FIGURE A: CR 510/RED ROAD ROUTES EVALUATED

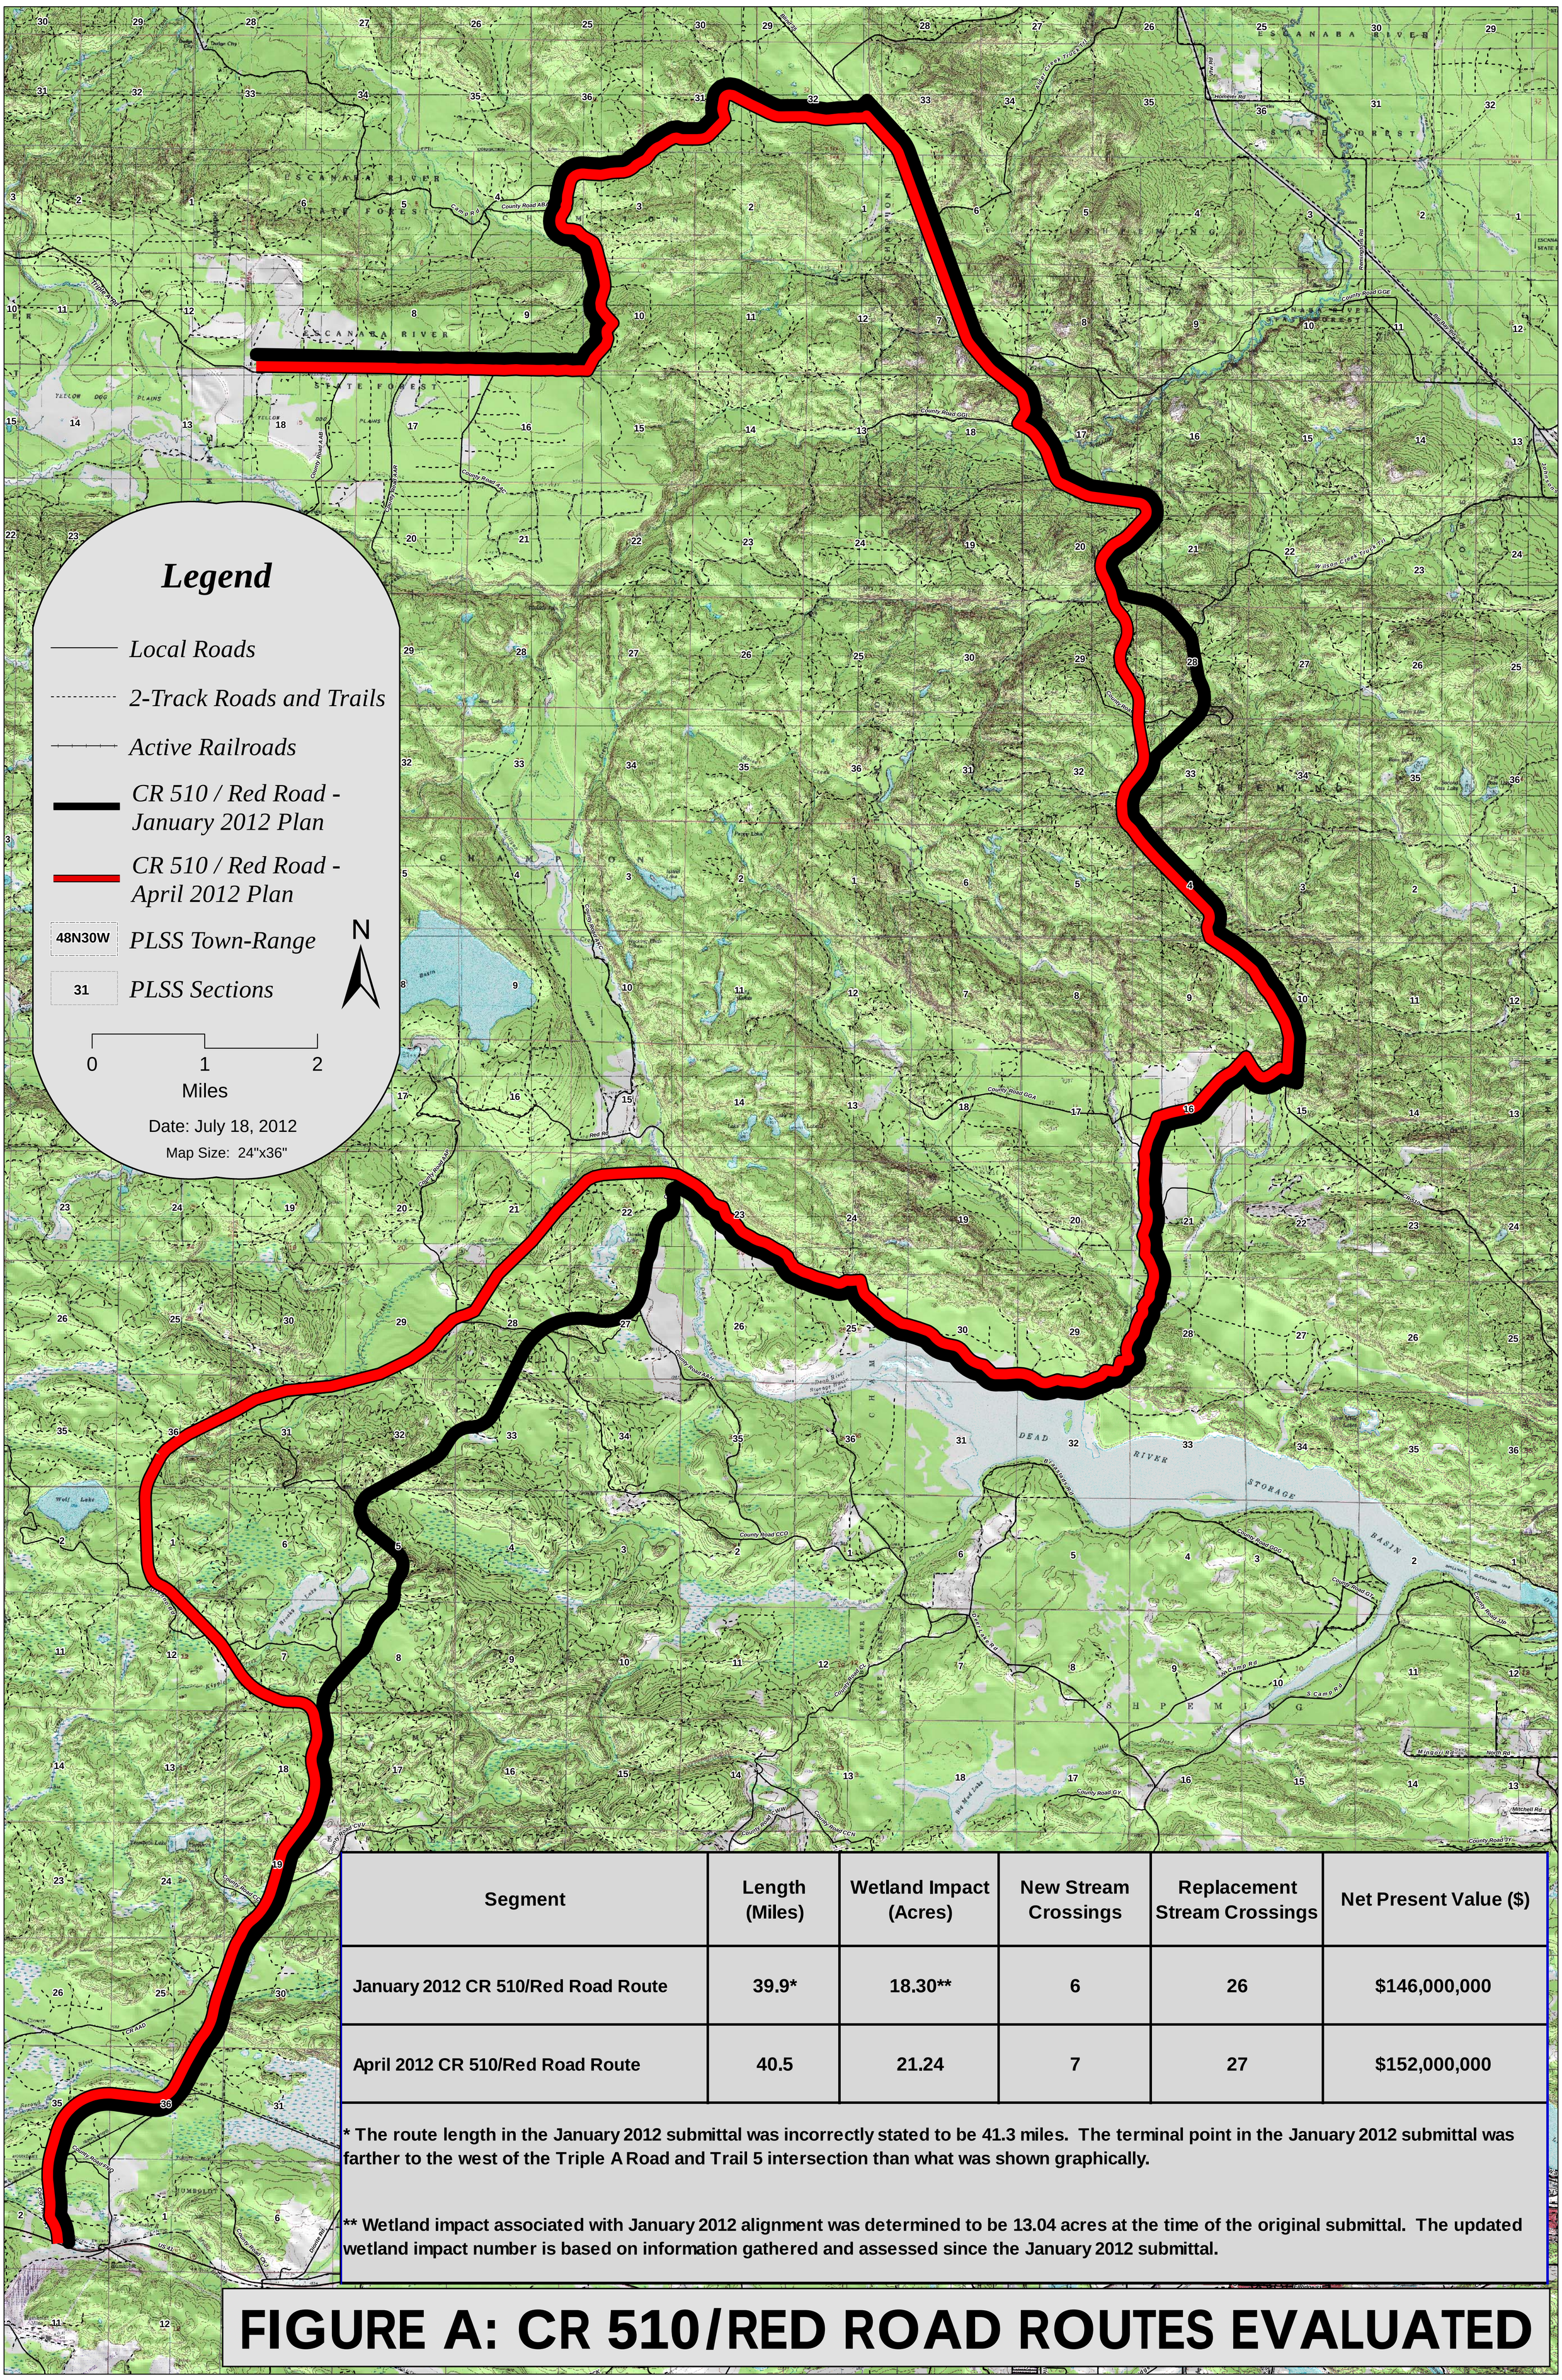
Segment	Length (Miles)	Wetland Impact (Acres)	New Stream Crossings	Replacement Stream Crossings	Net Present Value ($)
January 2012 CR 510/Red Road Route	39.9*	18.30**	6	26	$146,000,000
April 2012 CR 510/Red Road Route	40.5	21.24	7	27	$152,000,000

* The route length in the January 2012 submittal was incorrectly stated to be 41.3 miles. The terminal point in the January 2012 submittal was farther to the west of the Triple A Road and Trail 5 intersection than what was shown graphically.

** Wetland impact associated with January 2012 alignment was determined to be 13.04 acres at the time of the original submittal. The updated wetland impact number is based on information gathered and assessed since the January 2012 submittal.
